# Access Compliance Report

## Public Rights-of-Way

Intersection ID: 54374	Main Street: GRIER_RD	Cross Street: OLD_CONCORD_RD	Location:	E
ADA ID: E666111E9A51	Ramp Type: Perp	Initial Pass/Fail: Fail	Overall Compliance: No	Severity Score: 10
Codes/Mitigation Info/Possible Solution		Field Measurements/Component Compliance

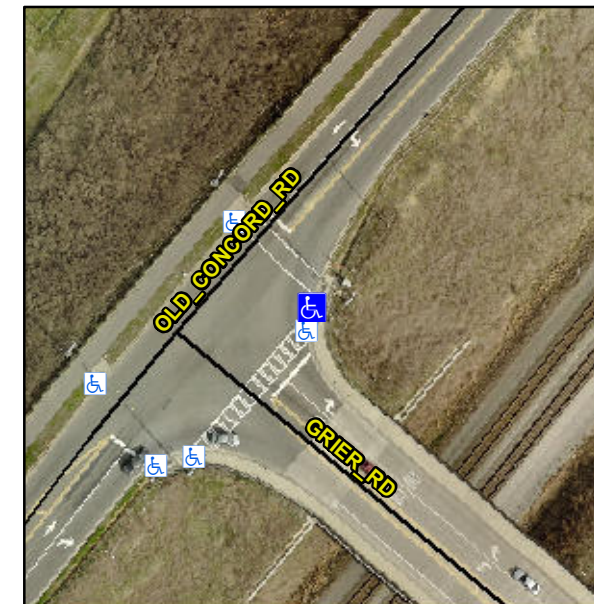
**Remove & Replace Entire Ramp.**

**R304.5.1, R304.5.3**

Compliance	Description	Data	Compliance	Description	Data
N/A	Ramp Length (in)	83.0	Yes	Ramp Slope (%)	7.2
No	Ramp Width (in)	47.0	No	Ramp XSlope (%)	3.7
N/A	Flare Type LT	N/A	N/A	Flare Type RT	N/A
N/A	Flare Slope LT (%)	N/A	N/A	Flare Slope RT (%)	N/A
N/A	Flare Traversable LT?	N/A	N/A	Flare Traversable RT?	N/A
N/A	Landing Length (in)	N/A	N/A	DWS Provided?	N/A
N/A	Landing Width (in)	N/A	N/A	DWS Contrast?	N/A
N/A	Landing Slope (%)	N/A	N/A	DWS Length (in)	N/A
N/A	Landing X Slope (%)	N/A	N/A	DWS Full Width?	N/A
N/A	Landing Curb? (Y/N)	N/A	N/A	DWS Offset (in)	N/A
N/A	Shared Landing?	N/A			
N/A	Gutter Ponding?	N/A	N/A	Gutter Slope (%)	N/A
N/A	Gutter Lip Ht (in)	N/A	N/A	Gutter X Slope (%)	N/A
N/A	Painted X Walk1?	Yes	N/A	Painted X Walk2?	N/A
	X Walk 1 Direction	To NW		X Walk 2 Direction	N/A
N/A	X Walk 1 Width (in)	105.0	N/A	X Walk 2 Width (in)	N/A
	X Walk 1 Slope (%)	4.2		X Walk 2 Slope (%)	N/A
	X Walk 1 X Slope (%)	1.4		X Walk 2 X Slope (%)	N/A
